STAFF REPORT 02-07-2024 REGULAR MEETING

APPLICATION NUMBER: HDC2024-00028

ADDRESS: 708 PALLISTER

SCOPE: ADD ROOF DORMERS, REHABILITATE DWELLING

1 SOUTH ELEVATION
SCALE: 1/8" = 1'-0"

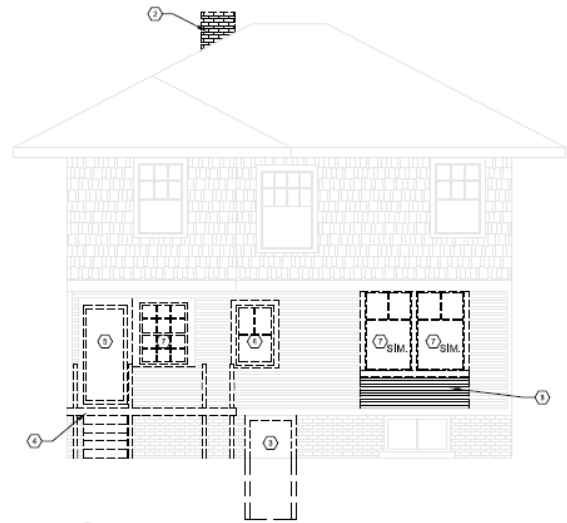
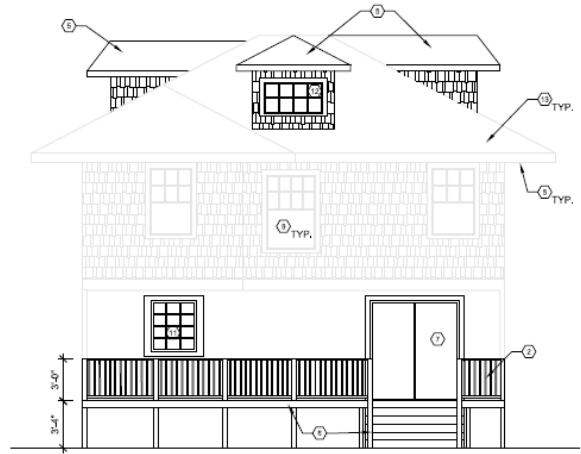
- Wood frame houses of this type often have wood frame porches; though staff has not located an earlier photo, it is highly likely that the house originally had an ornamental wooden porch, with wooden steps, that matched or exceeded the design quality of the rest of the building. The current plain concrete block porch, with steel support columns, existed legally at the time of historic designation in 1982, and can continue to be maintained in its present form, despite its abject lack of character. However, staff recommends that the owner, when feasible, seriously consider replacing this incompatible porch deck with a new wooden design that restores historic character. In the current application, the proposed wooden columns and balustrade are a positive first step, and their design is compatible with the house. The relocation of concrete steps to the front is reasonable and appropriate, in staff's opinion, given the porch's current non-historic condition and appearance.

- There are two major alterations proposed in today's application. The first is the addition of three additional dormers to the roof line, facing generally south (rear), west, and east (sides). They are proposed to receive a similar design treatment as the front-facing dormer (wood construction including shakes, with windows of an appropriate design). The construction of an east-facing dormer requires the removal of the historic chimney, which is of a utilitarian design. Though chimneys should typically remain on houses as an important roofline element enhancing complexity and texture, in this case staff does not assess that its removal for the dormer as demonstrably inappropriate. The dormers themselves are compatible additions to the property, do not destroy important historic character or sight lines, and are additionally compatible with the district's Elements of Design and the character of surrounding houses.

- The three 2/1 historic windows at the rear (two large paired windows, and one small individual window) are distinctive character-defining features and must be preserved; if new rear access is desired a less destructive solution incorporating a swinging door should be considered.
- The front porch and rear deck rail designs should be further developed, and distinct from each other, as they have different roles to play in the historic understanding of this house. The front porch rail should be historically correct, while the rear deck balustrade should be of a more contemporary character distinguishing the deck as a later addition.

2 NORTH ELEVATION
SCALE: 1/8" = 1'-0"

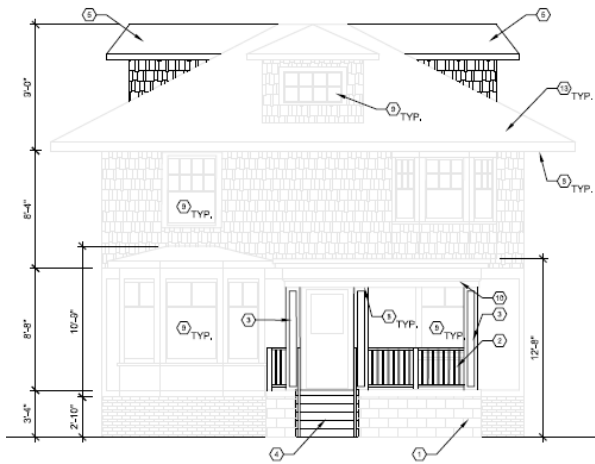
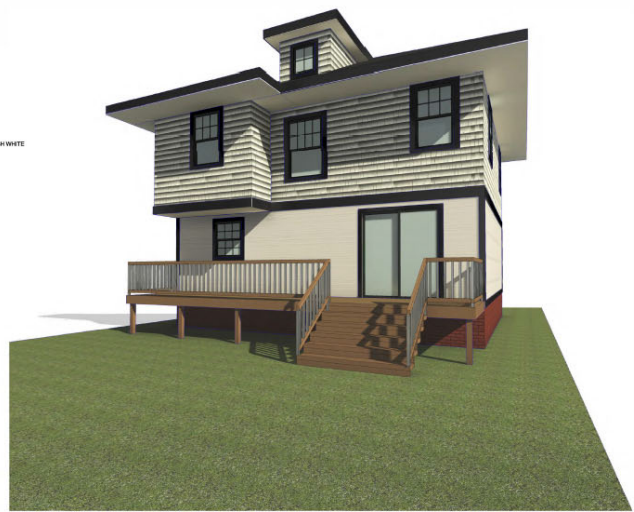
- The second major set of alterations in this proposal is to reconfigure the rear elevation, to include the installation of a modern sliding glass door in place of paired historic windows, the alteration of the existing door/window to a single window, the closing up of a small historic window with in-kind wood clapboard, and the addition of a full-width deck. Alterations to the rear of a property, as the Commission knows, are subject to the same historic character and appropriateness assessments as the front, if the rear is found to express significant and distinctive historic character.

- Staff assesses that the rear of 708 Pallister does indeed retain significant and important historic character; in fact, given that the original porch is missing from the front and has negatively impacted that elevation, the historic character of the front and rear are quite similar, in staff's opinion. In particular, the original paired 2/1 windows at the rear, which perfectly complement corresponding units on the front elevation, are improbably still intact and should be preserved. This 2/1 configuration is a relatively rare design in Detroit houses, and to see it still extant on a non-primary elevation is rarer still. Notice also how the building's "belly band", an apparently 8" width of trim board dividing the first floor from the second, serves as the top of the window framing for the bay window at the *front* of the house, continues around the west side, and then also serves as the top of the paired windows at the *rear* that are proposed for removal. This belly band similarly incorporates the line of the surviving historic porch roof and continues around the east side, fully encircling the building. The relationship between the rear 2/1 windows and the "belly band" is a deliberate and historically resonant design element that would be lost in the proposed alteration. In staff's opinion, removal of these paired windows and replacement with a modern sliding door assembly is inappropriate. If new access to the rear is desired, staff suggests that a smaller swing door, installed adjacent to the historic windows, may be a more appropriate option. This may or may not be possible given the interior layout, but the Commission's principal concern should be

- There is another small original 2/1 window at the rear, which is indicated to be removed and replaced with matching clapboard to accommodate interior reconfiguration. Though it is small, in the context of this house its surviving 2/1 design is important and valuable, and shows a deliberate and historically significant design decision on the part of the original designer. Staff recommends that it be preserved.

- The rear porch/deck design here is somewhat of a hybrid, in that it seeks to replace the location of a deteriorated earlier porch (which incidentally does **not** appear on the 1915 Sanborn map), and then continues to expand to the full-width of the historic house. In interpreting the drawings, especially the renderings, it appears that the deck is designed to be of modern construction, either stained or treated, differently from the painted wood of the historic house. This would be the most appropriate expression. However, the design for the railing (balustrade) of the rear deck is intended to be the same as the railing around the front porch. No detail drawing for either railing system is provided. In staff’s opinion, the railing/balustrade at the front porch and steps should be a historic design (painted, with interior balusters mounted in-between the top/bottom rails), while the rear deck should be of a modern design (unpainted, with “outboard” balusters fastened into the side of the top/bottom rails, or a similar contemporary design not intended to appear historic). “Setting off” the modern deck as an obvious addition to the original composition, in the manner described above, would help preserve the understanding of the core historic house, which is consistent with NPS guidelines.
